City of Alexandria, Virginia

MEMORANDUM

SUBJECT: CONCEPT REVIEW OF 806 NORTH COLUMBUS STREET
BAR CASE # 2025-00373

Figure 1: View of proposed townhouses looking south on North Columbus Street

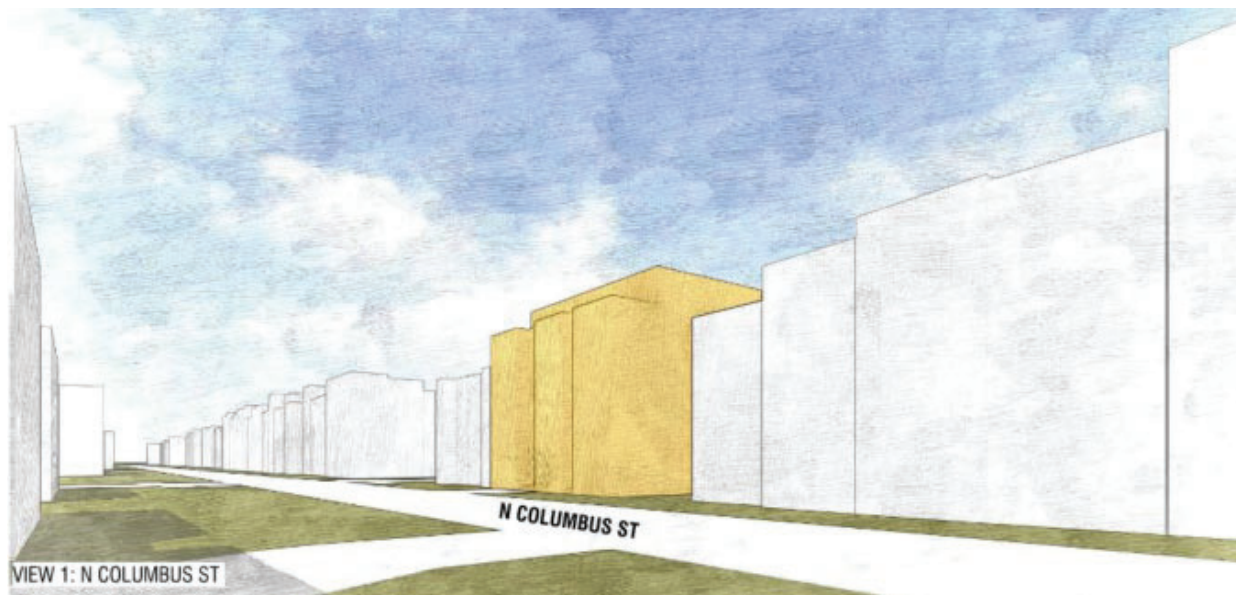
The proposed townhouses are three stories at the front side and step up to a fourth floor approximately 13'-0" from the front face of the building (Figure 1&2). The front part of this setback area will be occupied by a roof deck and solid parapet. The fourth-floor massing will include a low slope roof that slopes towards the rear of the building.

2 PROPOSED FRONT ELEVATION
1/4" = 1'-0"

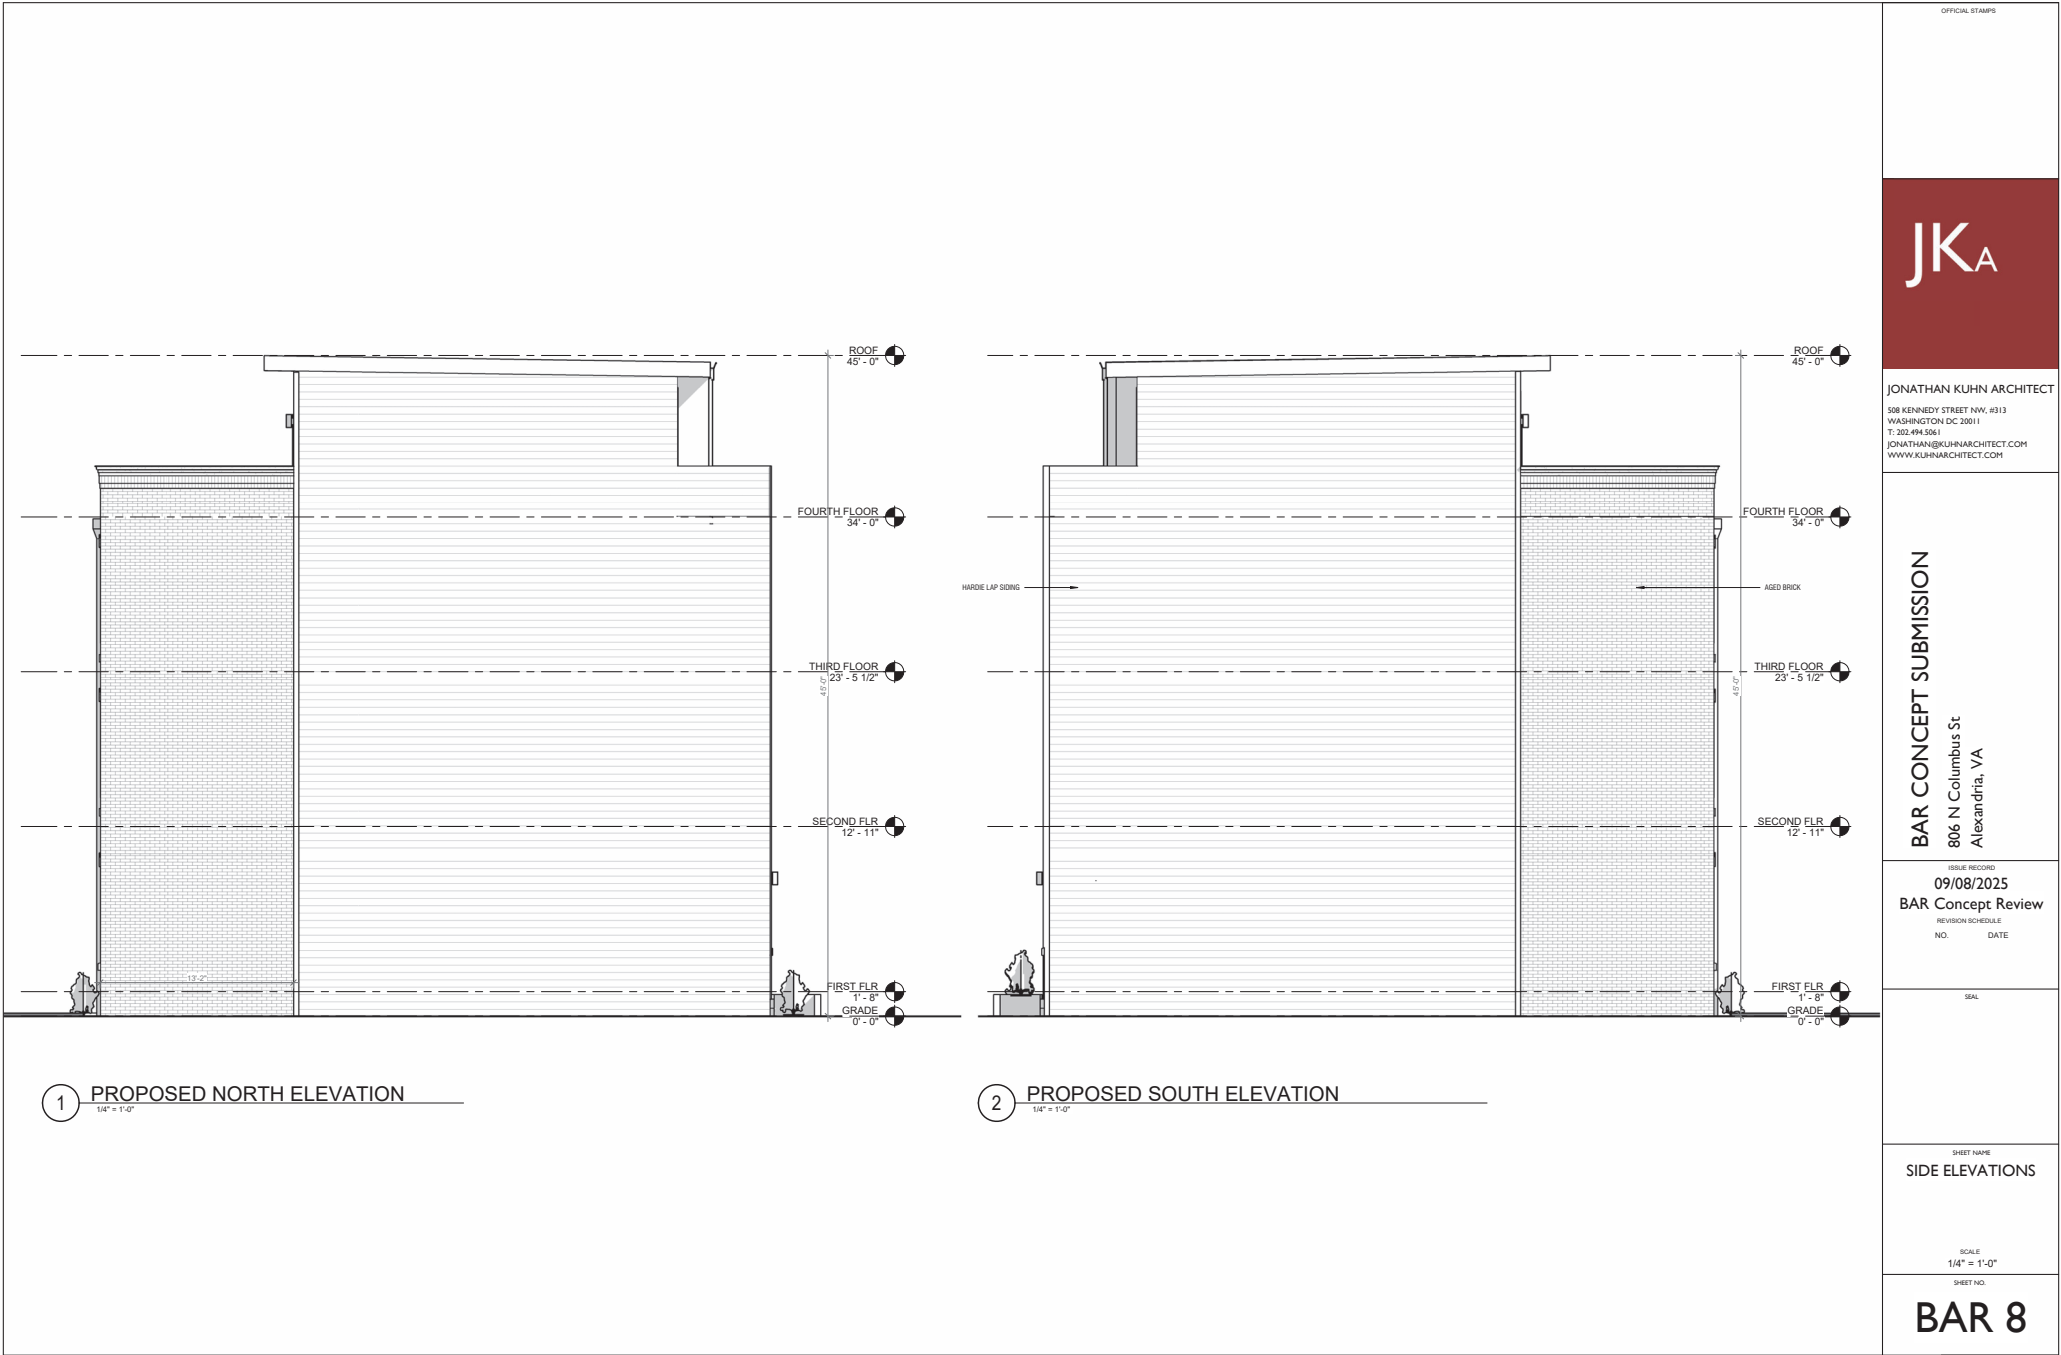
The proposed townhouses will be clad in a combination of brick and fiber cement siding (Figures 3&4). The two outer townhouses will be 18'-3" wide and feature a projecting bay of three punched windows with the entry door located in the recessed section of the façade. The center townhouse will be 16'-0" wide with a projecting bay of two punched windows and the entry door below punched windows in the recessed section. The street facing elevation of the fourth floor will include operable glazed doors and a transom. The front portion of the building will be clad in brick with the transition to fiber cement siding occurring on the sides aligned with the set back fourth floor. This siding will encompass the fourth floor and the rear of the building. At the rear of each townhouse, the fourth floor will be set back 3'-6" from the lower floors and will include simple glazed doors. A grouping of three punched windows will be located at the second and third floors above an operable glazed door at the ground floor.

The proposal includes elevations for the visible portions of the exterior; however as it is early in the design process there remains a greater level of detail and three dimensional views to be produced. The buildings will be clad in brick at the street facing elevation and this brick will extend across a portion of the long elevation to align with the front of the set back portion of the fourth floor. The street facing façade will be dominated by punched window openings at the second and third floors and a large, ganged window at the ground floor. Staff finds the use of brick transitioning to fiber cement siding to be compatible with the nearby structures. The use of punched windows is similar to windows found on historic structures; however the solid to void ratio of the proposed design includes more glazed areas than typically found on historic buildings.

- Examine the amount and spacing of windows on the front façade to be compatible with the solid to void ratio typically found on structures in the historic district.
- The proposed windows on the front façade use a four over four lite configuration. This configuration is not typically found in the historic district. The applicant should consider alternate lite configurations.
- The submission shows a brick base at the front façade, a stone base at the rear and no base at the side. A singular base detail should be developed to tie the different portions of the building together.
- Corner boards are inconsistently shown at the corners of the fiber cement siding. This detail should be further refined.
